Access Compliance Report

Public Rights-of-Way

(Curb Ramps)

Intersection ID: 29384	Main Street: KIERNAN_DR	Cross Street: PLEASANT_DALE_DR	Location: NW
ADA ID: C4FF7BAF1085	Ramp Type: Perp	Initial Pass/Fail: Fail	Overall Compliance: No
Severity Score: 13.75			
Codes/Mitigation Info/Possible Solution		Field Measurements/Component Compliance

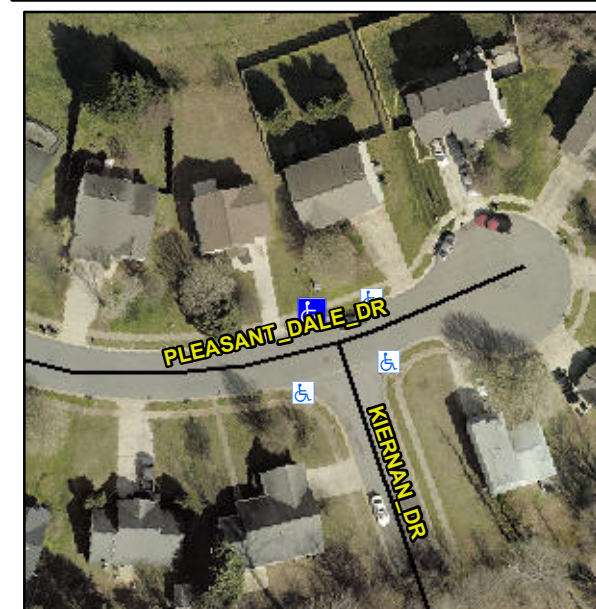
Not Found, R304.2.2, R304.5.3

Compliance	Description	Data	Compliance	Description	Data
N/A	Ramp Length (in)	47.0	No	Ramp Slope (%)	8.4
Yes	Ramp Width (in)	48.0	No	Ramp XSlope (%)	4.6
N/A	Flare Type LT	N/A	N/A	Flare Type RT	N/A
N/A	Flare Slope LT (%)	N/A	N/A	Flare Slope RT (%)	N/A
N/A	Flare Traversable LT?	N/A	N/A	Flare Traversable RT?	N/A
N/A	Landing Length (in)	N/A	N/A	DWS Provided?	N/A
N/A	Landing Width (in)	N/A	N/A	DWS Contrast?	N/A
N/A	Landing Slope (%)	N/A	N/A	DWS Length (in)	N/A
N/A	Landing X Slope (%)	N/A	N/A	DWS Full Width?	N/A
N/A	Landing Curb? (Y/N)	N/A	N/A	DWS Offset (in)	N/A
N/A	Shared Landing?	N/A			
N/A	Gutter Ponding?	N/A	N/A	Gutter Slope (%)	N/A
N/A	Gutter Lip Ht (in)	N/A	N/A	Gutter X Slope (%)	N/A
N/A	Painted X Walk1?	No	N/A	Painted X Walk2?	N/A
	X Walk 1 Direction	To SW		X Walk 2 Direction	N/A
N/A	X Walk 1 Width (in)	N/A	N/A	X Walk 2 Width (in)	N/A
	X Walk 1 Slope (%)	4.5		X Walk 2 Slope (%)	N/A
	X Walk 1 X Slope (%)	0.8		X Walk 2 X Slope (%)	N/A

Remove & Replace Entire Ramp.
